Work Order ID 84541

Item Name: 205 Skidtube bent detail

DESIGN	4	DART AEROSPACE LTD	
DRAWN	RF	HAWKESBURY, ONTARIO, CANADA	
CHECKED	10	DRAWING NO.	REV. E
MFG. APPR.	10	D2580	SHEET 2 OF 8
APPROVED	10	TITLE	SCALE
DE APPR.	10	205 SKIDTUBE ASSEMBLY	NTS
DATE	11.06.21	<small>COPYRIGHT © 1996 BY DART AEROSPACE LTD THIS DOCUMENT IS PRIVATE AND CONFIDENTIAL AND IS SUPPLIED ON THE EXPRESS CONDITION THAT IT IS NOT TO BE USED FOR ANY PURPOSE OR COPIED OR COMMUNICATED TO ANY OTHER PERSON WITHOUT WRITTEN PERMISSION FROM DART AEROSPACE LTD</small>

DRAWING NO. D2580	TITLE 205 SKIDTUBE ASSEMBLY	REV. E	DART AEROSPACE LTD ENGINEERING ORDER	D.E.O. NO. D2580-E-1	SHEET NO. SHEET 1 OF 1	SCALE NTS
DRAWN <i>AP</i>	CHECKED <i>ASS</i>	MFG. APPR. <i>ER</i>	APPROVED <i>[Signature]</i>	DE APPR. <i>[Signature]</i>		
DATE 11.12.13	DATE 11.12.13	DATE 11.12.13	DATE 11.12.13	DATE 11.12.13

SECTION B-B
SCALE 5X

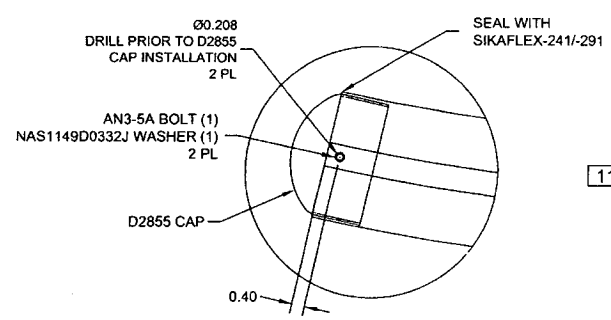
- AFTER DRILLING AND BENDING ASSEMBLY PERFORM THE FOLLOWING FOR Ø0.508 HOLES ONLY:
1. CHAMFER HOLE 0.050 X 45°
 2. INSERT D2579 SPACER (20 PLACES)
 3. WELD INTO PLACE AND GRIND FLUSH
 4. C'BORE D2579 SPACER TO Ø0.437 X 1.00 DEEP

SECTION B-B, SECTION F-F, & SECTION I-I ARE AMENDED AS FOLLOWS
FOR ALL HOLES THAT WERE ORIGINALLY C'BORED:

1. INSERT D4202-1 SPACER, 20 PL (-041) OR 20 PL (-045) OR 25 PL (-047)
2. SWAGE TO Ø0.437 X 1.00 DEEP PER QSI 002
3. TRIM / GRIND FLUSH PER QSI 002

SECTION F-F
D5-5
SCALE 5X

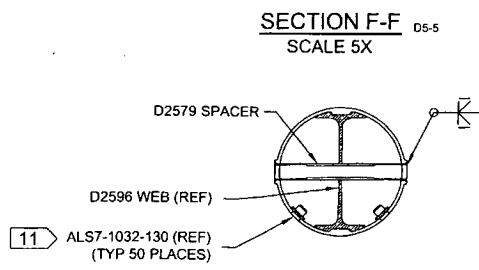
- AFTER DRILLING AND BENDING ASSEMBLY
PERFORM THE FOLLOWING FOR Ø0.508 HOLES ONLY:
1. CHAMFER HOLE 0.050 X 45°
 2. INSERT D2579 SPACER (24 PLACES)
 3. WELD INTO PLACE AND GRIND FLUSH
 4. C'BORE D2579 SPACER TO Ø0.437 X 1.00 DEEP

SECTION B-B, F-F, I-I
NOT TO SCALE

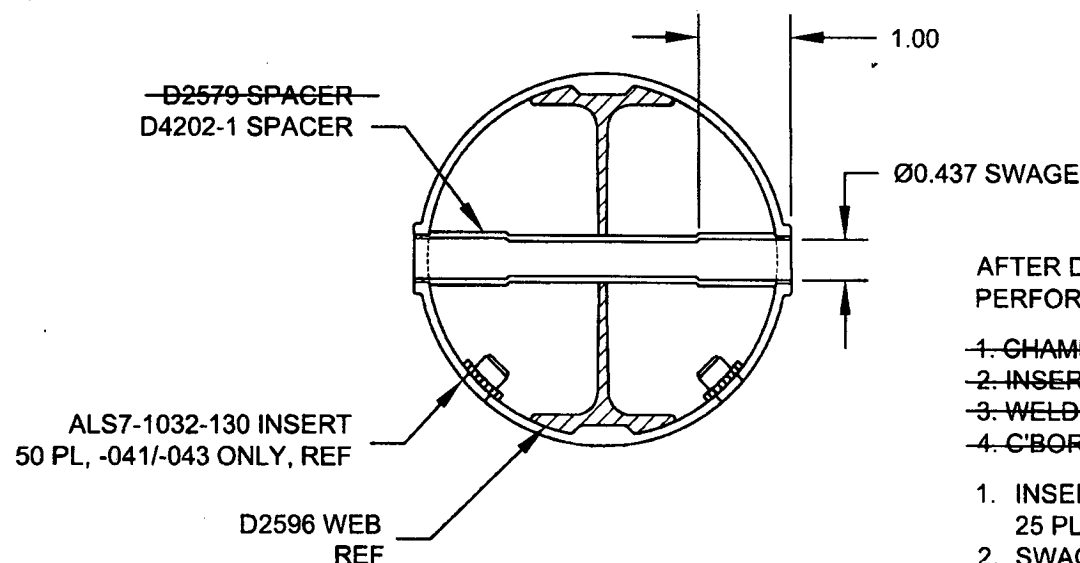
PURPOSE:

CHANGE ALL C'BORED WELDED CROSSBOLT SPACERS TO SWAGED SPACERS

*** FOR -045 SKIDTUBE ONLY:**

WELD 4X D2579 SPACERS PER DWG
IN LOCATIONS MARKED "NO C'BORE".
REF SHEET 4 OF DWG.

AFTER DRILLING AND BENDING ASSEMBLY
PERFORM THE FOLLOWING FOR Ø0.508 HOLES ONLY:

1. CHAMFER HOLE 0.050 X 45°
2. INSERT D2579 SPACER (20 PLACES)
3. WELD INTO PLACE AND GRIND FLUSH
4. C'BORE D2579 SPACER TO Ø0.437 X 1.00 DEEP
